Subject: Appeal of the Design Review Board's approval of the color to be used on the 300 foot high offsite KOVR-TV Transmission Tower.

Location: Gateway Center, 2213 Ventura Oaks Way.

Subject: TV Tower Color and Base Structure

**TOWER AND  
EQUIPMENT  
BUILDING**

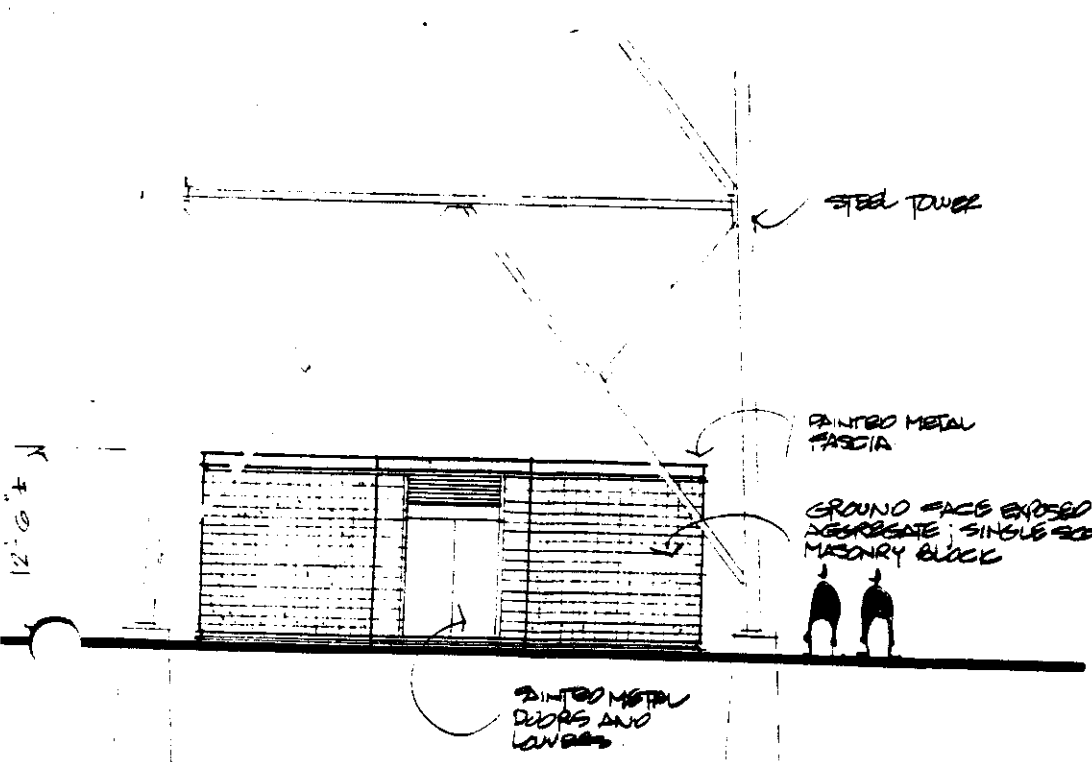
PROJECT EVALUATION: The transmission tower will be tripodal in plan with three legs rising 300 feet into the sky. A modified triangler tower building, for support equipment, will be placed at the base of the tower between the three legs. Cross bracing will run up the tower between each leg. The bracing changes in design as it moves up the tower. The legs and the bracing will be of round stock. An access ladder will run up one side of the tower. An exposed aggregate concrete block will be used on the equipment building.

1. The bracing at the base to only have one row of compound angles before changing to the simple triangle bracing. Base bracing to be similar to photo of tower supplied by applicant.
2. Dish locations to be placed within tower in place of an attachment to the outside of tower if possible.
3. Color of tower to be light tan or light blue gray. Dishes to be placed on tower to be the same color if possible.
4. Final landscaping and irrigation plans to be reviewed by staff.
